TEAM TIP

Communication #: L-18-10-02

Model Year(s): 2016-2018

SUBJECT: GEM BRAKE PEDAL ADJUSTMENT

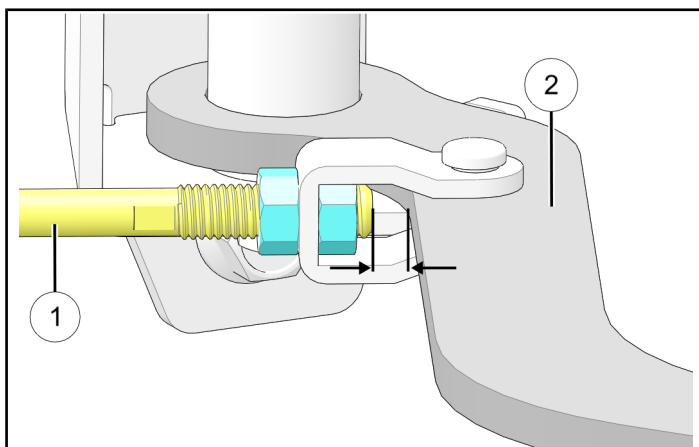
GEM has identified some 2016-2018 vehicles that have an improperly adjusted brake master cylinder push-rod.

When inspecting the brake master cylinder push-rod ① if it is contacting the brake pedal arm ②, it is improperly adjusted. There should be a minimum of **1/8" (3.18 mm)** clearance between the end of the push-rod and the brake pedal arm. There should also be free-play in the brake pedal when lifted upwards. If these two characteristics are not met, **reference the BRAKE SYSTEM chapter > BRAKE PEDAL ADJUSTMENT** procedure in the service manual.

Push-rod to Pedal Arm Clearance:
1/8" (3.18 mm) minimum
